GW - 16

Re: Renewal Discharge Permit, GW-016
Eunice Gas Plant
SE/4 SE/4 of Section 5, Township 21 South, Range 36 East, NMPM,
Lea County, New Mexico

**Re: Discharge Plan Renewal Permit GW-016
DCP Midstream L.P.
Eunice Gas Plant
Lea County, New Mexico**

Photo 13: Fluids held in containment of Photo 12.

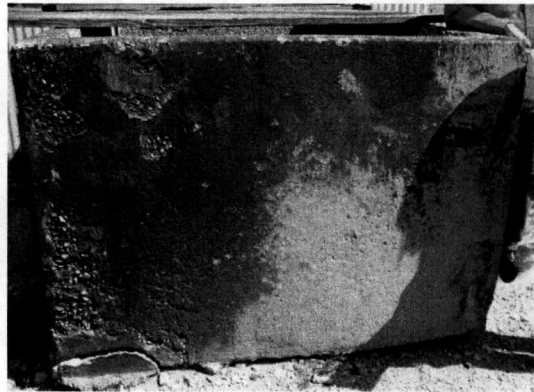
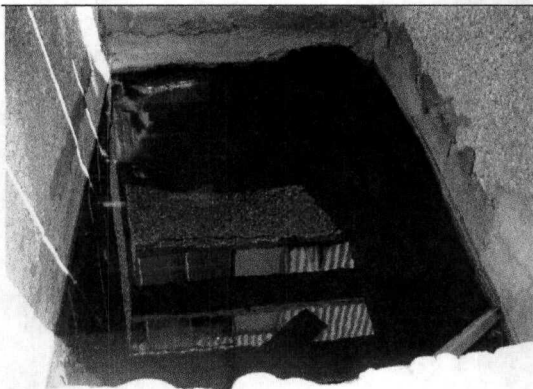
4. **Photo 12 - 13:** A small pond was identified near the old pump house. These fluids serve no function for the operating facility. Owner/Operator shall immediately prevent any more fluids from entering the containment area and shall test the fluid for TPH, Chlorides and constituents specified at 20.6.2.3103A NMAC, **Except** for Uranium (U) and Radioactivity (combined Radium - 226 and Radium - 228) and submit the results to OCD for review. Owner/Operator shall submit a work plan to close this containment. Disposal of water will be determined on the results of the fluid analysis.

Photo 14: Compressor pad.

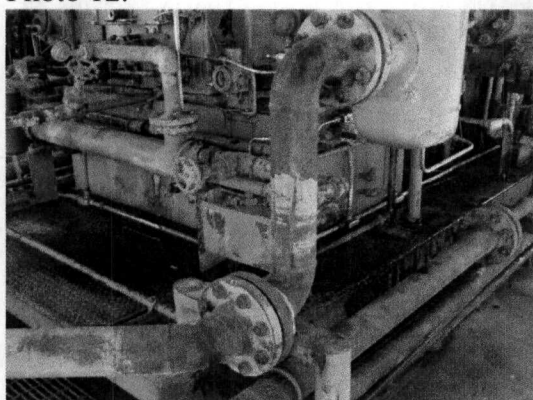
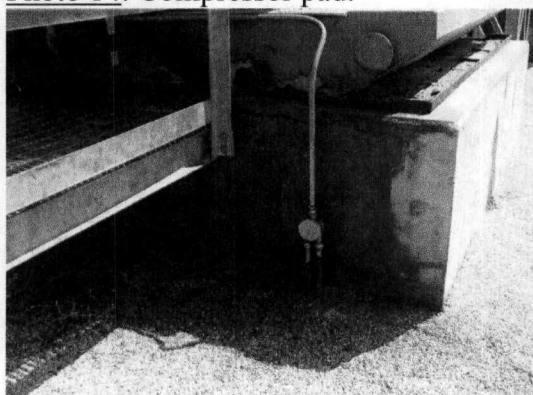
5. **Photo 14 - 16:** Owner/Operator shall monitor the integrity of their compressor skids. There are indications of integrity loss and seepage of the cement foundation. Owner/Operator shall submit a plan detailing how this will be monitored.

Photo 20: A new BGT installed on the western side of facility.

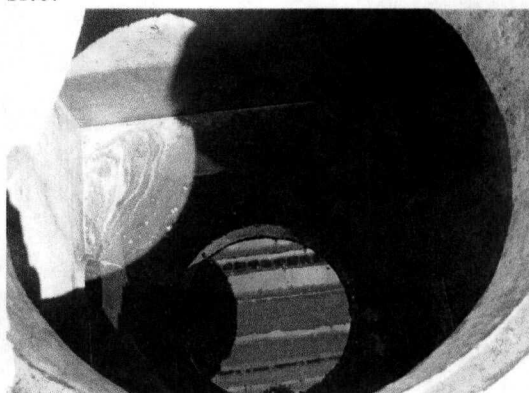
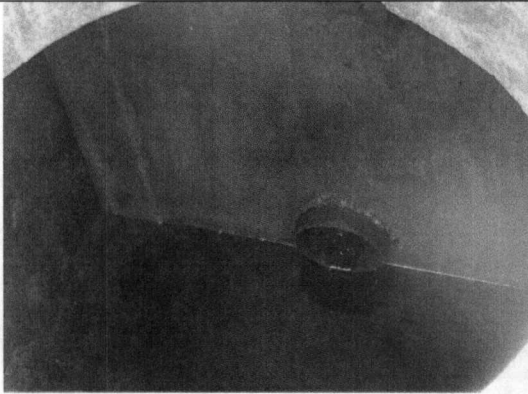
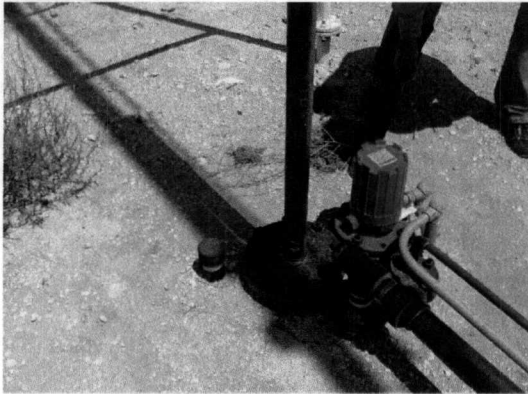
6. **Photo 17 - 20:** There were eight below-grade tanks identified onsite, seven of which were single wall tanks. (Photo 20) One below-grade tank located on the far west side of the facility had been recently installed. It is unclear if the newest tank is double walled with a leak detection system. Owner/Operator will submit a work plan to bring its BGT in accordance to Condition 11. Work plan shall include procedures to close the BGT if appropriate.
